## CHARLOTTE HISTORIC DISTRICT COMMISSION

### CERTIFICATE OF APPROPRIATENESS

**CERTIFICATE NUMBER:** HDCADMRM-2019-00419

**ADDRESS OF PROPERTY:** 1535 Southwood Ave

Front door – proposed

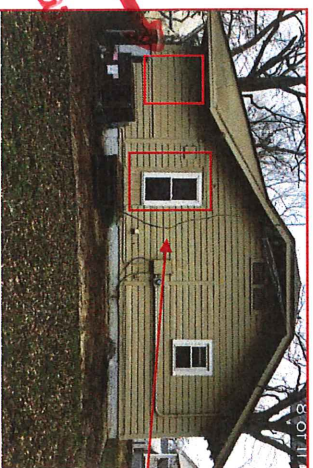
**No Dentil  
Detail**

French doors – proposed

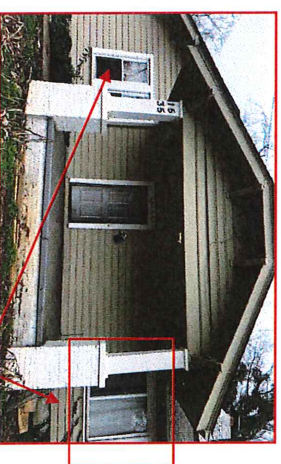
**No Inswing Mini Blind  
AKA: Blinds Between Glass**

**Full Commission Request**

Stair style – neighbors have the same

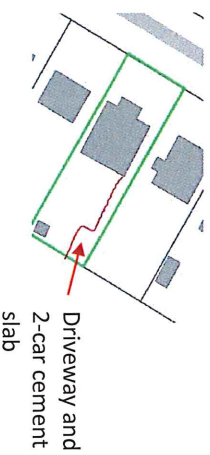
3' WIDE MAX

Draft deck rendering

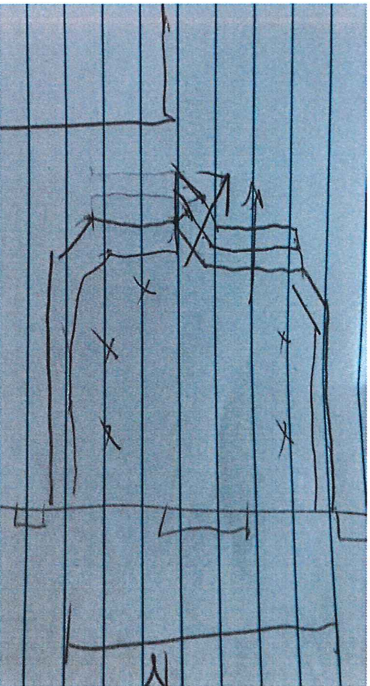
**Wood Only –  
No alternative materials**
